NORTH ANNA POWER STATION, UNIT NO. 1

AMENDMENT TO FACILITY OPERATING LICENSE

Amendment No. 154  
License No. NPF-4

ATTACHMENT TO LICENSE AMENDMENT NO. 154

Figure 2.1-1a REACTOR CORE SAFETY LIMITS FOR THREE LOOP OPERATION FOR THE PERIOD OF OPERATION UNTIL STEAM GENERATOR REPLACEMENT

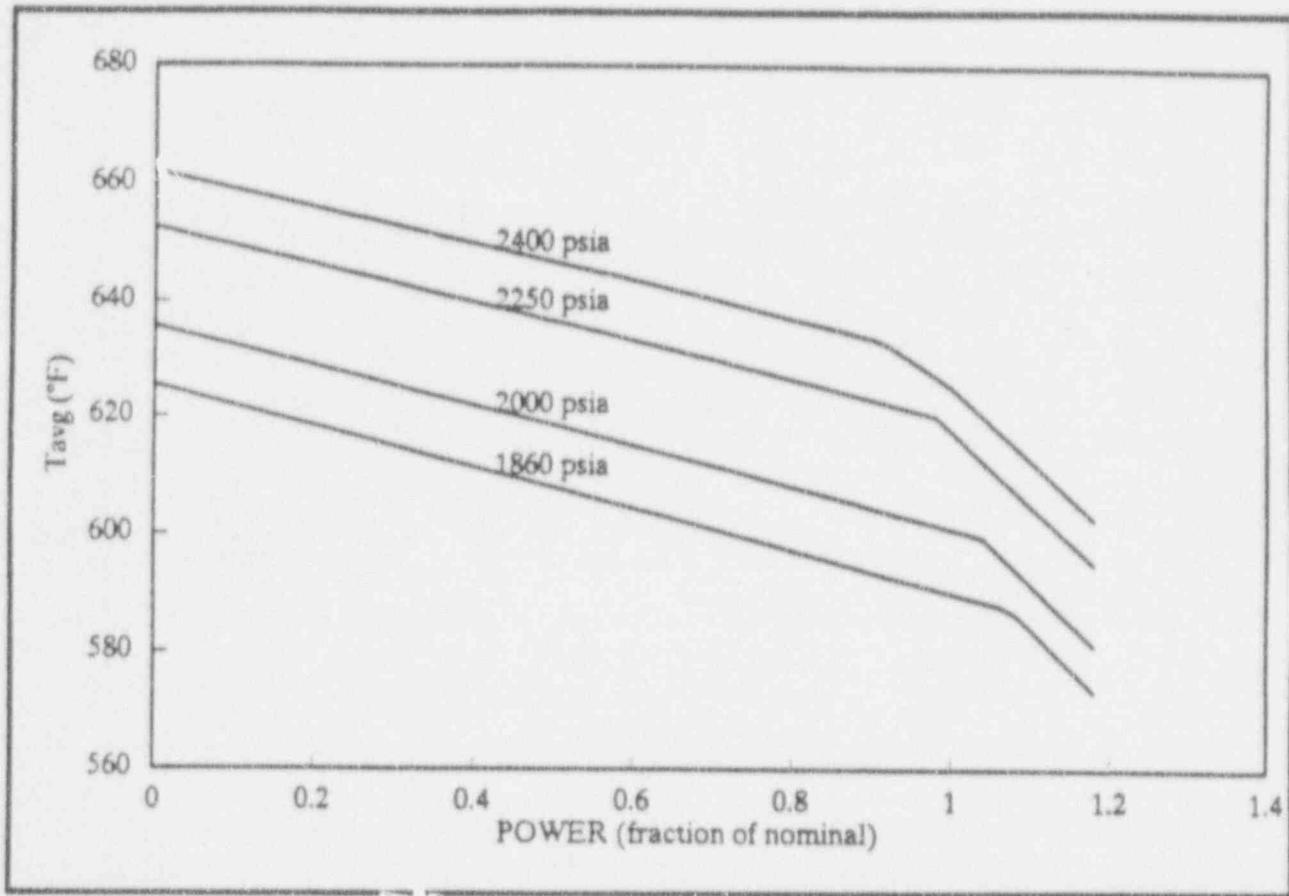
\* For the period of operation until steam generator replacement, the combination of THERMAL POWER, pressurizer pressure, and the highest operating loop coolant temperature ( $T_{avg}$ ) shall not exceed the limits shown in Figure 2.1-1a.
